UNITED STATES
DEPARTMENT OF THE INTERIOR
BUREAU OF LAND MANAGEMENTFORM APPROVED
OMB NO. 1004-0137
Expires: January 31, 2018**SUNDRY NOTICES AND REPORTS ON WELLS**
*Do not use this form for proposals to drill or to re-enter an abandoned well. Use form 3160-3 (APD) for such proposals.***SUBMIT IN TRIPLICATE - Other instructions on page 2**

UPDATE TO SUNDRY 377524:

SAN JUAN 32-5 UNIT NP 101

API No. 30-039-24338

Lateral #2 directional plans attached.

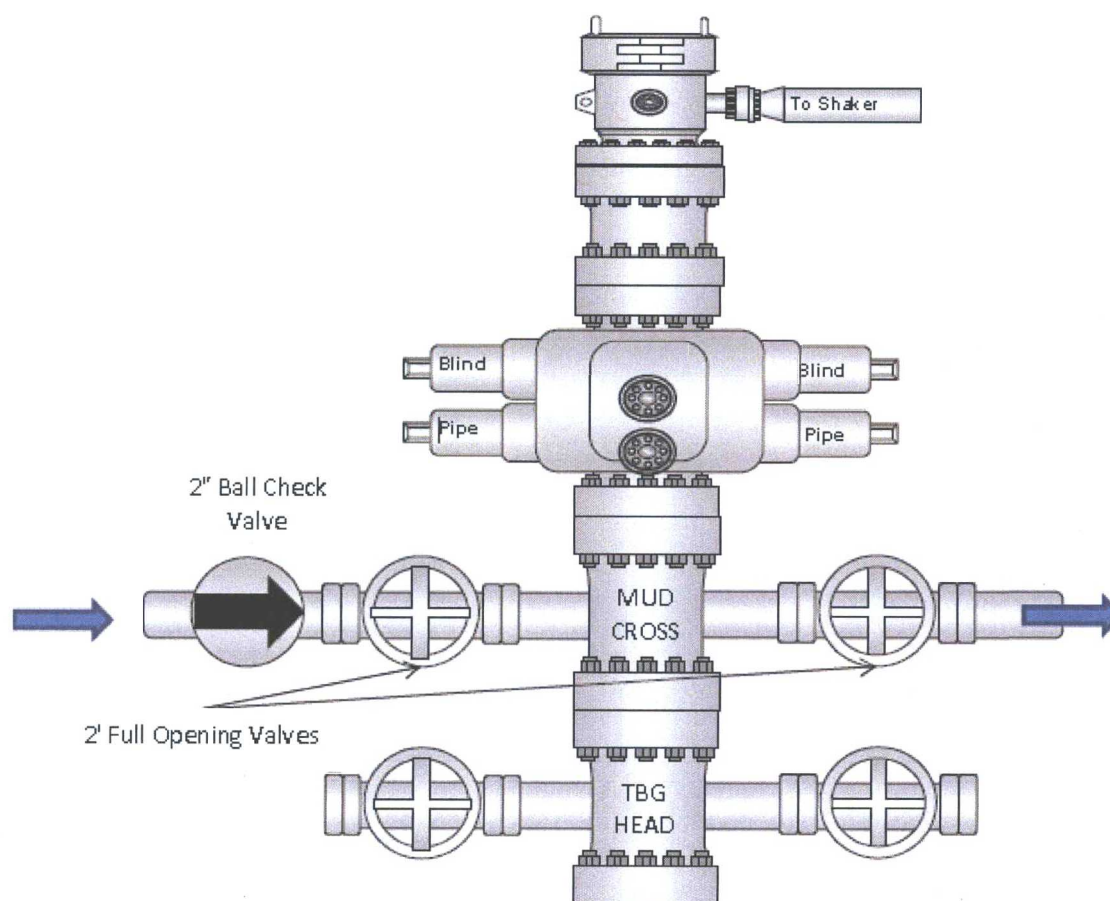
CHANGE:

SRC will be drilling a 6 1/8" lateral hole.

We will be running 4.5" 11.6# N-80 BTC pre-perforated with 4spf, 90deg phasing, 0.75" dia hole, and 1' blank on each end.

PREVIOUS:

Previous hole size and liner were 4 3/4" and 2 7/8".
